Global Nuclear Fuel

January 29, 2001

Subject: Non-Proprietary Application for the New Powder Container (NPC) Package and
Withdrawal Request for Protection of Proprietary Information

Explanation of Changes

Figure 2.1-1 - Sectional View of the GNF NPC Packaging

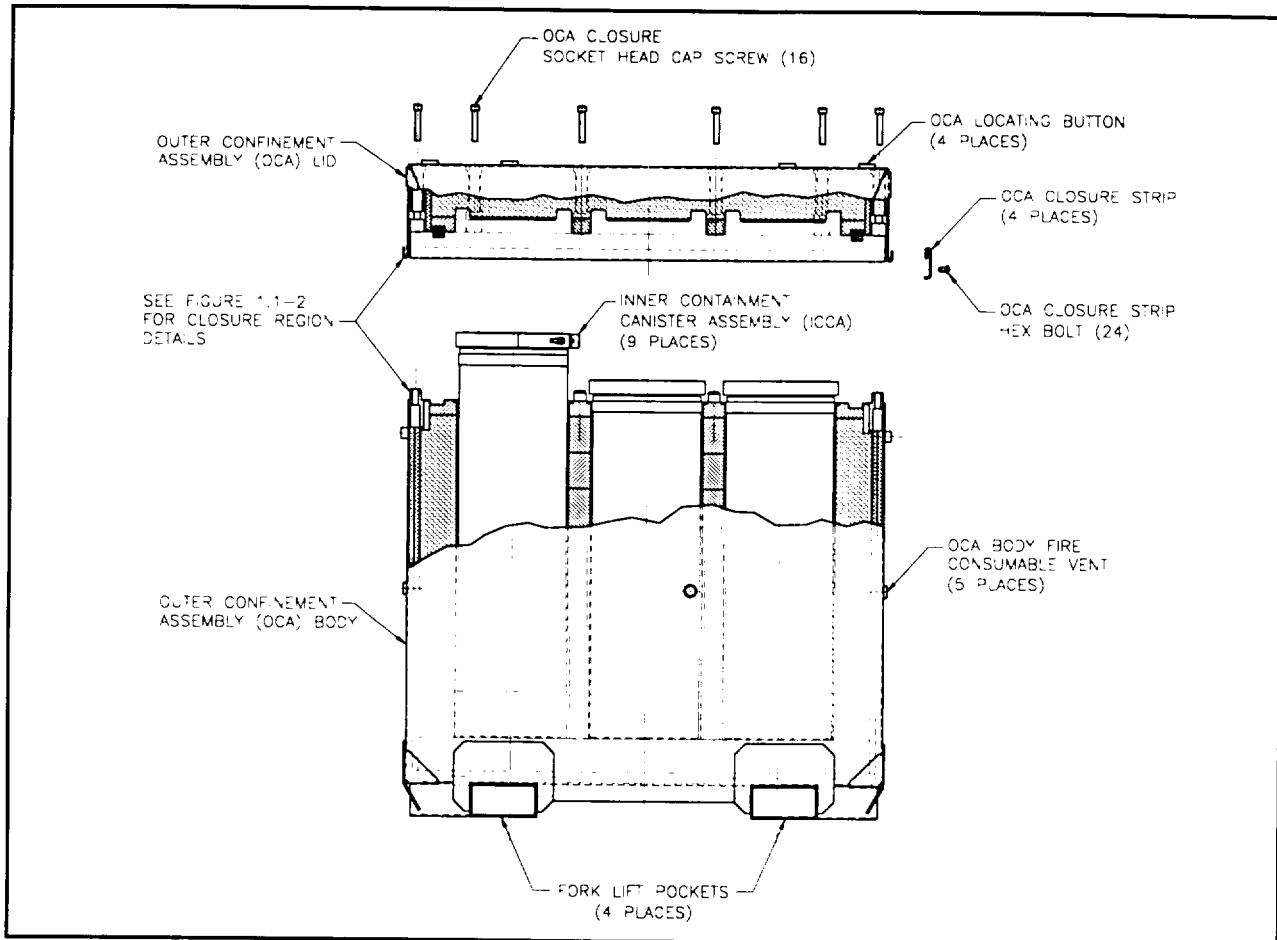
Page	Section	Explanation
2-2	Figure 2.1-1	Changed the wording "(Patent Pending)" to "Patent #6,166,391".
2-6 through 2-7	2.5.2	Clarified the blocking and bracing for securing the package within the transport vehicle.
7-1	7.1	Removed the last sentence, because there is no longer a distinction between proprietary and non-proprietary drawings.
7-2	7.1.2, 3.	Clarified the loading procedure.
7-2	7.1.2, 4.	Added a new 4. to clarify the loading procedure.
7-2	7.1.2, 5. Through 9.	As a result of adding a new 4., the previous items 4. through 8. became 5. through 9.
7-2	7.1.2, 8.	Clarified wording.
7-3	7.1.3, 6.	Clarified the package preparation instructions and assured that they are consistent with Section 2.5.2.
7-3	7.1.3, 7.	Clarified the package preparation instructions and assured that they are consistent with Section 2.5.2.
7-3	7.1.3, 8.	Clarified the package preparation instructions and assured that they are consistent with Section 2.5.2.
